# UNITED STATES PATENT AND TRADEMARK OFFICE

APPLICATION NO.	FILING DATE	FIRST NAMED INVENTOR	ATTORNEY DOCKET NO.	CONFIRMATION NO.
09/846,054	04/30/2001	John R. Gustafson	K35A0459	4487
35219	7590	05/27/2004	EXAMINER	
WESTERN DIGITAL TECHNOLOGIES, INC.			BLOUIN, MARK S	
20511 LAKE FOREST DR. -C205			ART UNIT	PAPER NUMBER
LAKE FOREST, CA 92630			2653	9

# Office Action Summary

EXAMINER'S DRAWING

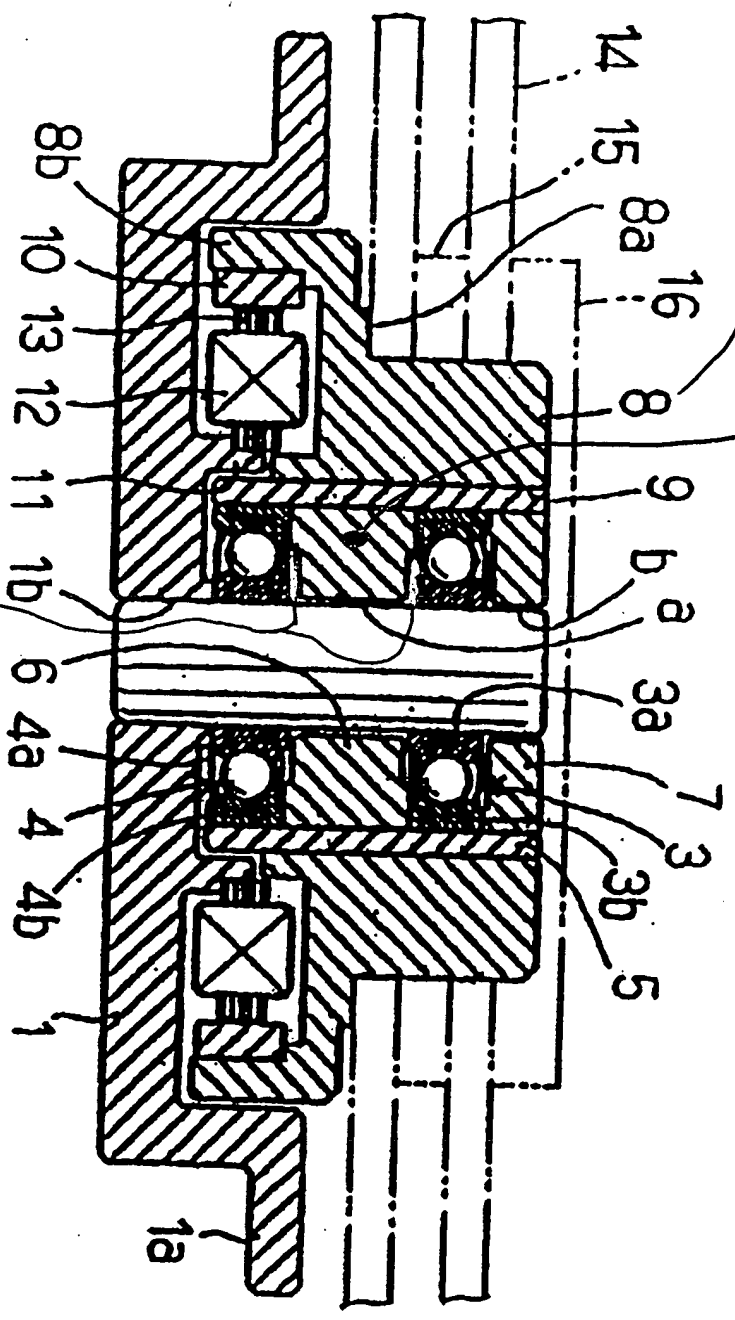
attached to the shaft, a second outer race (4b), a second ball (4) set between the second inner race and the second outer race, and a rotary hub (8) surrounding the shaft, the hub defining a hub extension (6), (See Examiner's Drawing), configured to exert a pre-loading force on the first inner race, the pre-loading force being directed toward the second inner race, and a hub extension between the first and second bearings that extends from the rotary hub toward the longitudinal axis beyond the first and second outer races and between the first and second inner races.

4. Regarding Claims 2 and 32, Obara shows (Figs. 1 and 3) the spindle motor, wherein the hub extension (6) is unitary and integral with the rotary hub (See Examiner's Drawing).

5. Regarding Claims 6 and 36, Obara shows (Figs. 1 and 3) the spindle motor, wherein the first and second outer races are attached to the rotary hub and wherein the hub extension (6) extends between the first and second bearings so as to form a first gap between the hub extension and at least a portion of the first inner race and a second gap between the hub extension and at least a portion of the second inner race (See Examiner's Drawing).

Co-hary  
hub

Hub Extension (Unhary and integral with co-hary hub)

GAP BETWEEN 1st and 2nd INNER RINGS
